APPEAL SUMMARY

Appeal ID: 18957	Project Address: 820 SE Alder St
Hearing Date: 2/6/19	Appellant Name: Iain MacKenzie
Case No.: B-009	Appellant Phone: 5032200668
Appeal Type: Building	Plans Examiner/Inspector: Maureen McCafferty
Project Type: commercial	Stories: 10 Occupancy: R-2, A-2, A-3, S-2, B Construction Type: Type I-B
Building/Business Name: Alder.9	Fire Sprinklers: Yes - Throughout
Appeal Involves: Erection of a new structure	LUR or Permit Application No.: 18-261126-CO
Plan Submitted Option: pdf [File 1] [File 2]	Proposed use: Residential / Retail

ALDER.9TH
820 SE ALDER ST.

A1.00

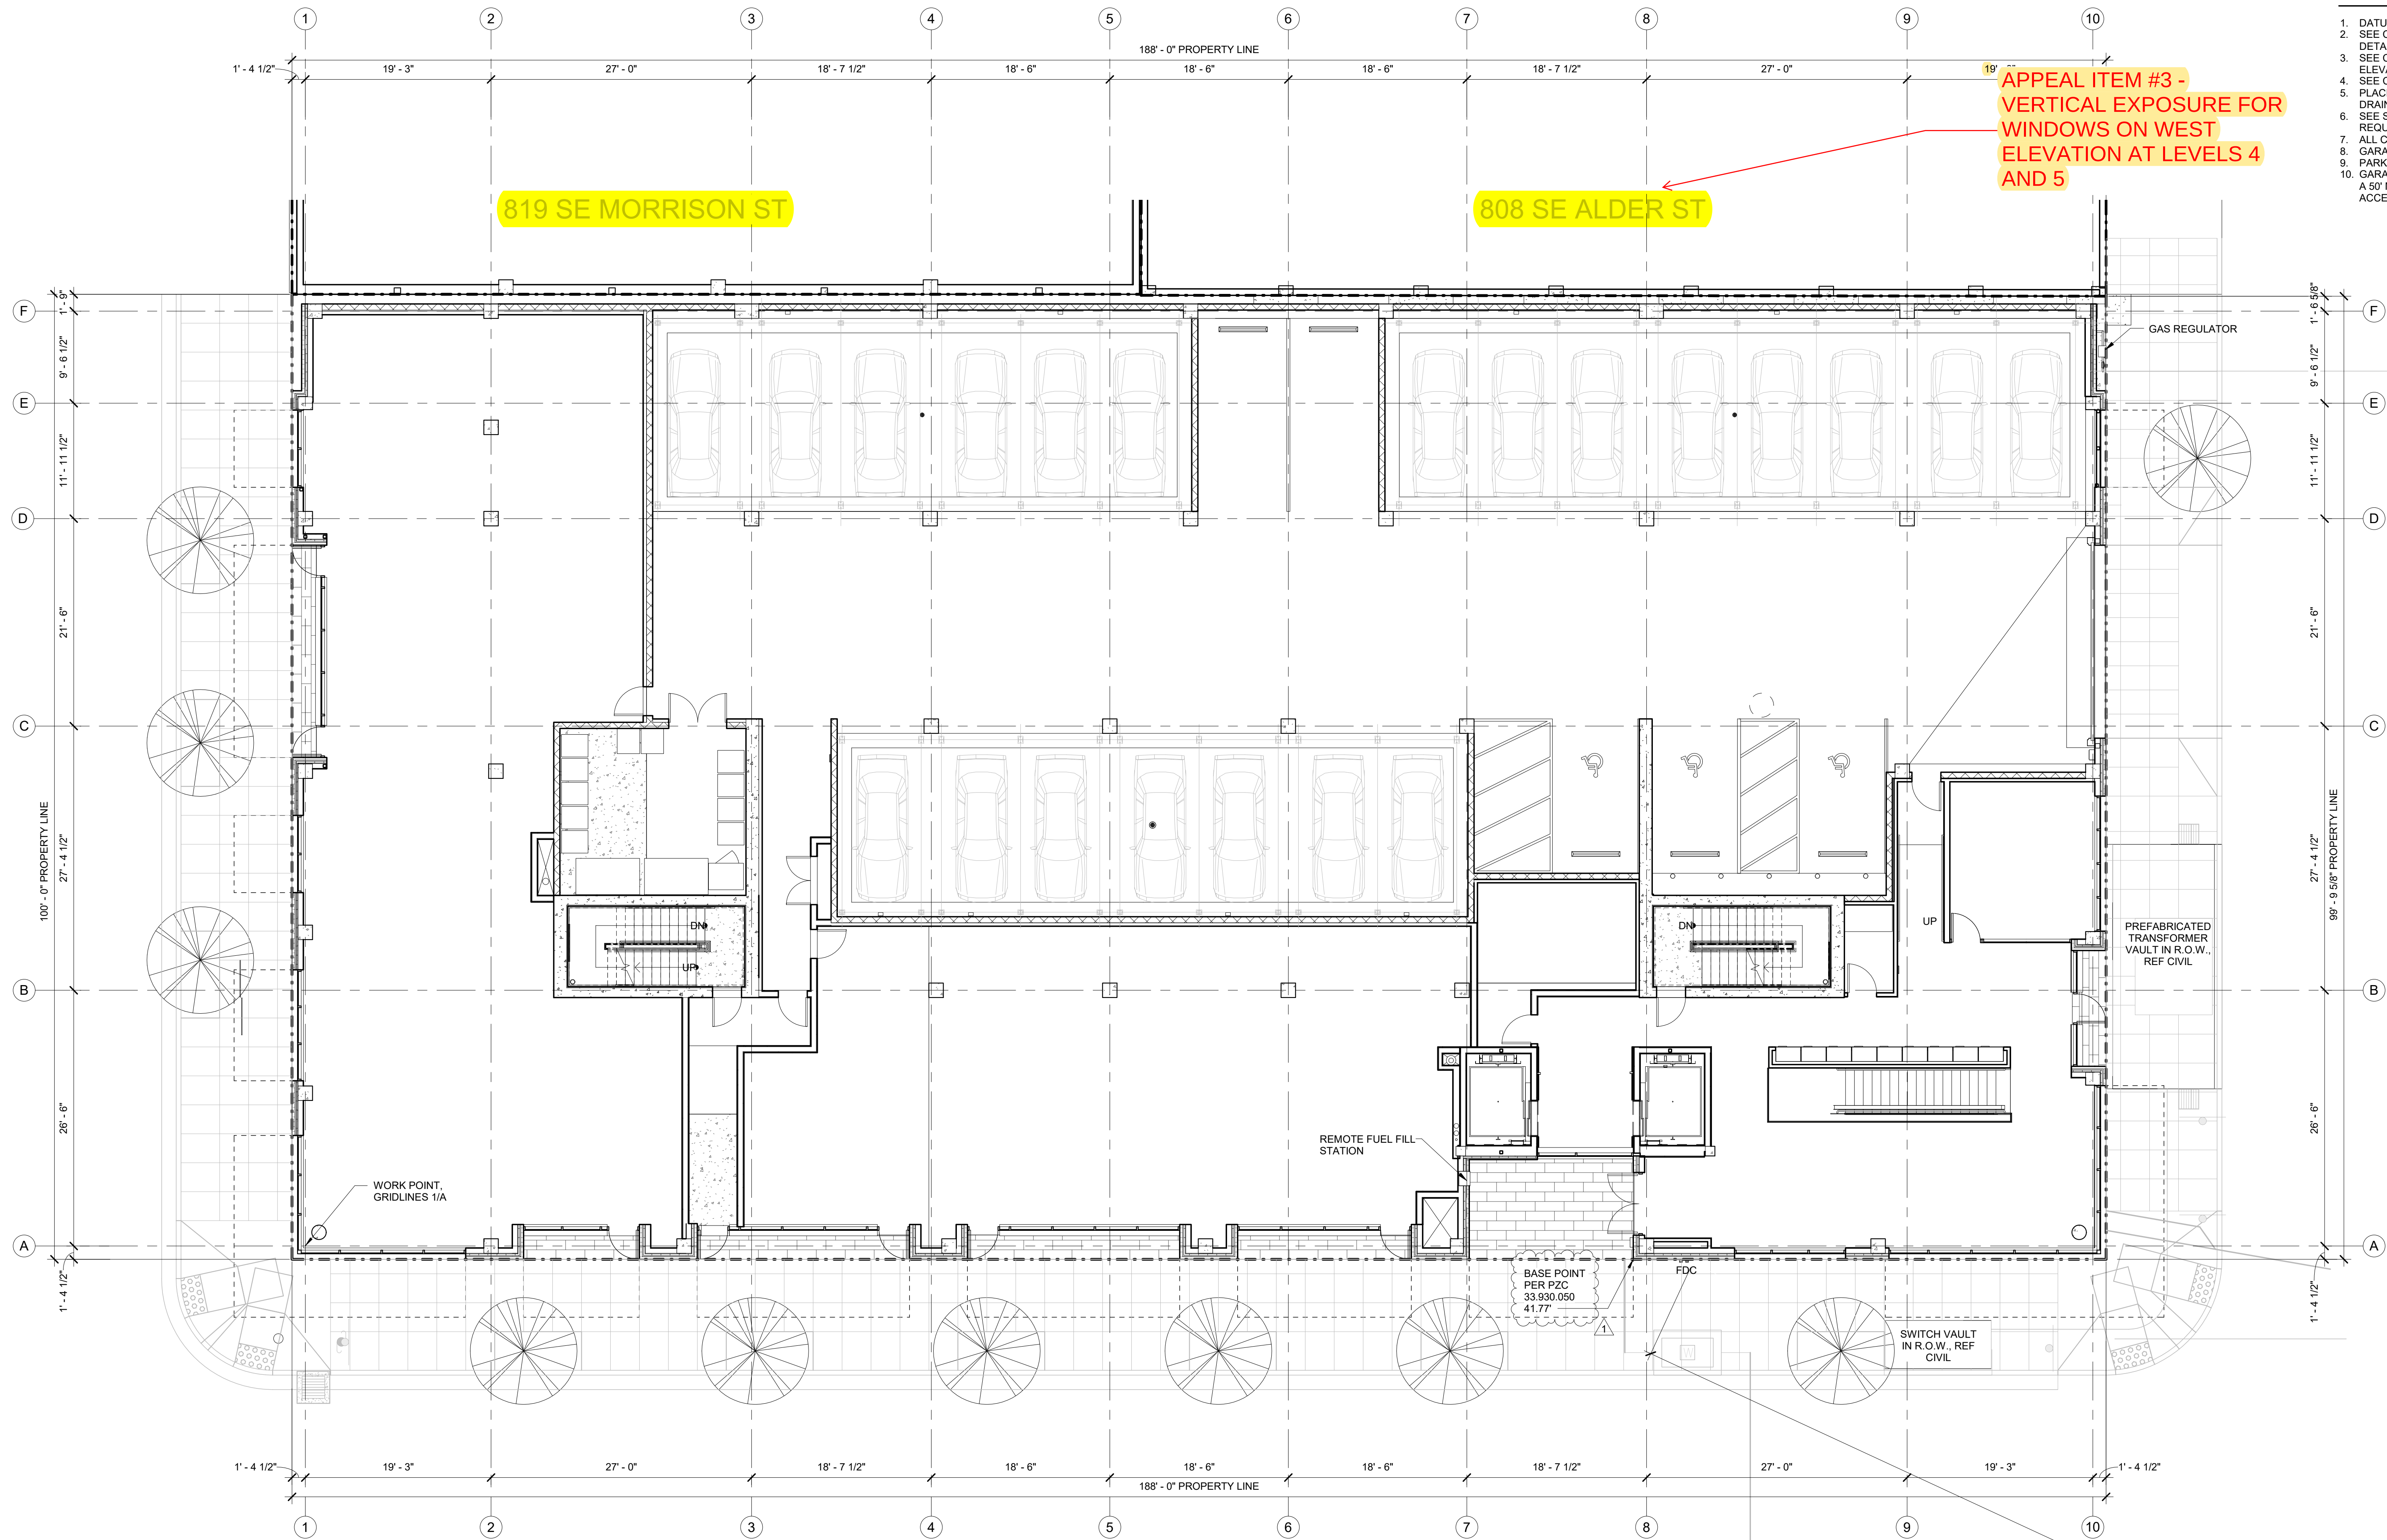
Proposed Design Windows subject to this requirement are located on the west elevation at levels four and five, at the corridor end walls and in units 401, 417, 418, 432, 501, 517, 518 and 532.

Instead of providing fire rated glazing it is proposed make the windows non-operable, with additional sprinkler protection. Sprinkler heads are to be spaced not more than 6 feet apart and placed a minimum of 6 inches and a maximum of 12 inches from the opening(s) and a maximum of 12 inches below the ceiling. Sprinklers are to be installed on the occupied side of the openings and are to be capable of wetting the entire window surface.

APPEAL ITEM #3 -
VERTICAL EXPOSURE FOR
WINDOWS ON WEST
ELEVATION AT LEVELS 4
AND 5

3. Type 13 water curtain sprinkler protection at non-fire rated openings in buildings with vertical exposure on separate lots: Granted provided windows are non-operable and sprinklers are spaced not more than 6 feet apart and placed a minimum of 6 inches and a maximum of 12 inches from the opening(s) and a maximum of 12 inches below the ceiling. Sprinklers are to be installed on the occupied side of the openings. A separate permit from the Fire Marshal's Office is required.

1 LEVEL 01 FLOOR PLAN
1/8" = 1'-0"

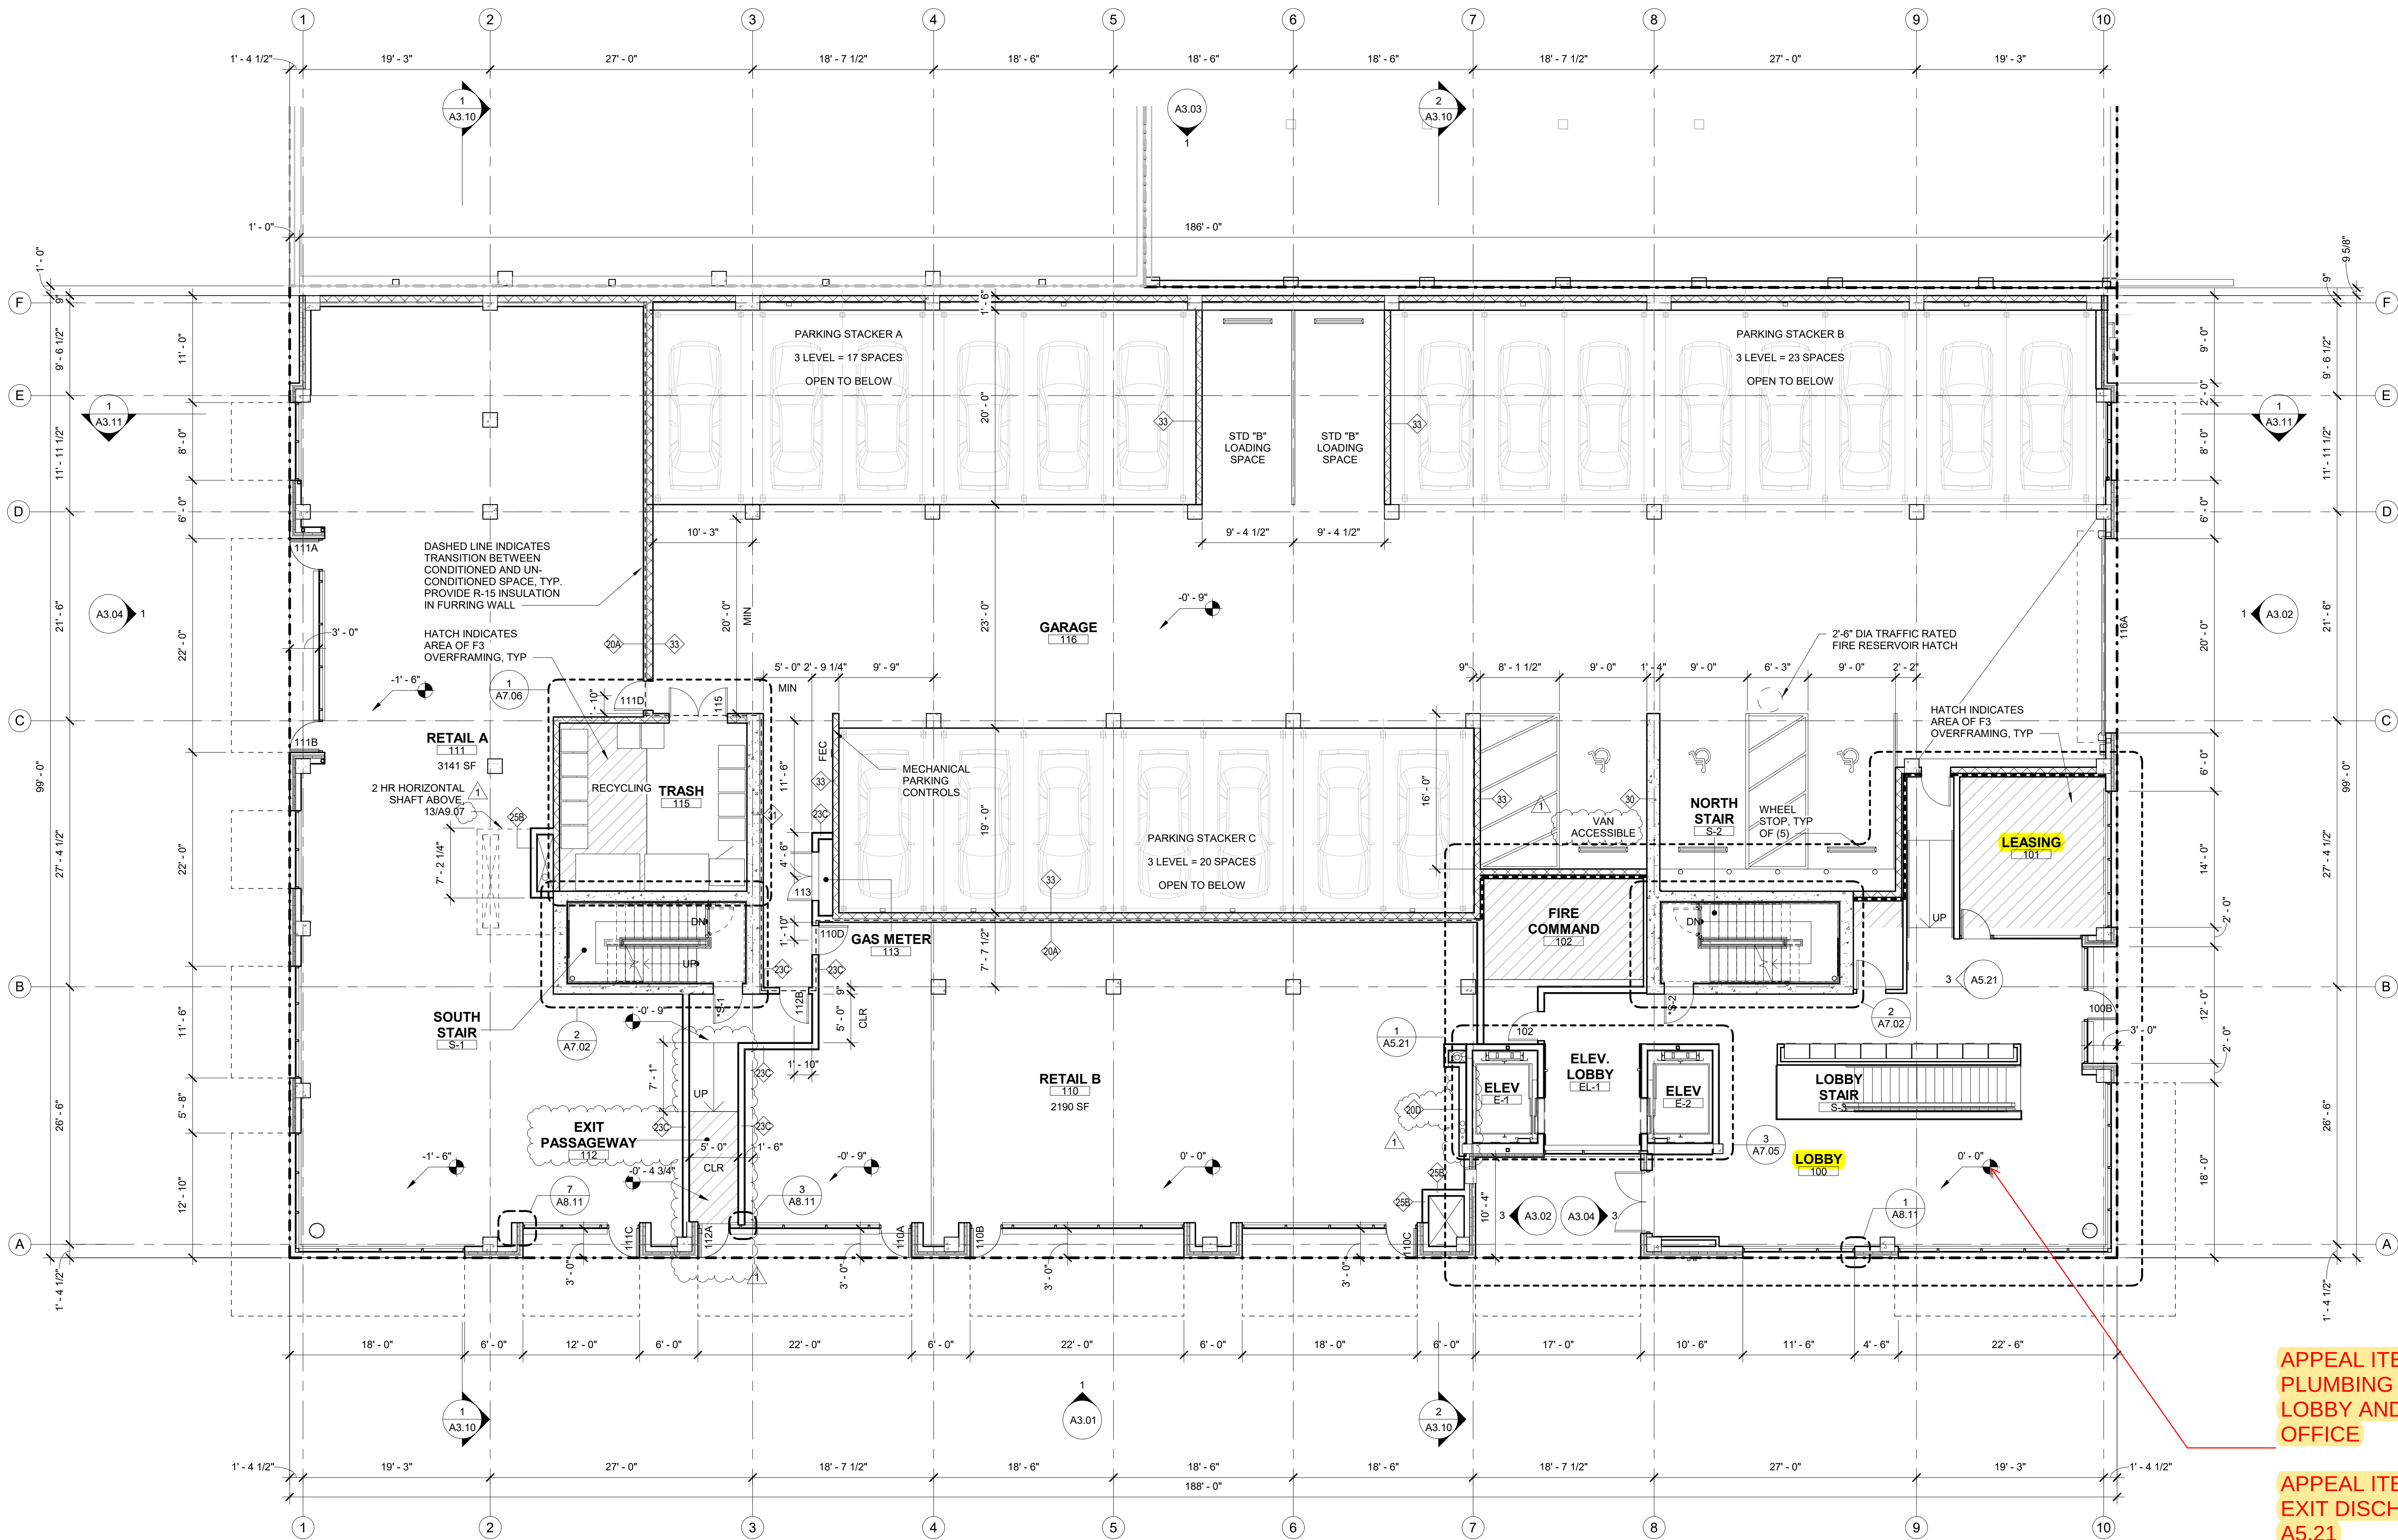
Proposed Design The north stair core, one of two serving the building, discharges to the lobby. The lobby has two exits to the right-of-way.

- a) Mailboxes are located in the lobby, along the path of travel to one of the exits. The life safety examiner for the project has raised the concern that these will potentially be an obstruction.
- b) An open stair connects the lobby to the dog wash room in the basement below. The dog wash room is a 1,022 sq ft room with a B occupancy and an occupant load of 11. Its perimeter walls all have fire ratings of two hours.

APPEAL ITEM #1 -
PLUMBING FIXTURES AT
LOBBY AND LEASING
OFFICE

APPEAL ITEM #2A & 2B -
EXIT DISCHARGE. REF
A5.21

1. Reduction in minimum required plumbing fixtures in tenant only amenity spaces: Granted provided 2nd floor toilet room is available for general use and provided signage is located at amenity spaces with location of toilet room.

2a. Mailboxes located along exit stair egress path: Granted provided they comply with requirements of ANSI 307 for protruding objects.

2b. Separation of exit discharge from areas below: Granted as proposed.
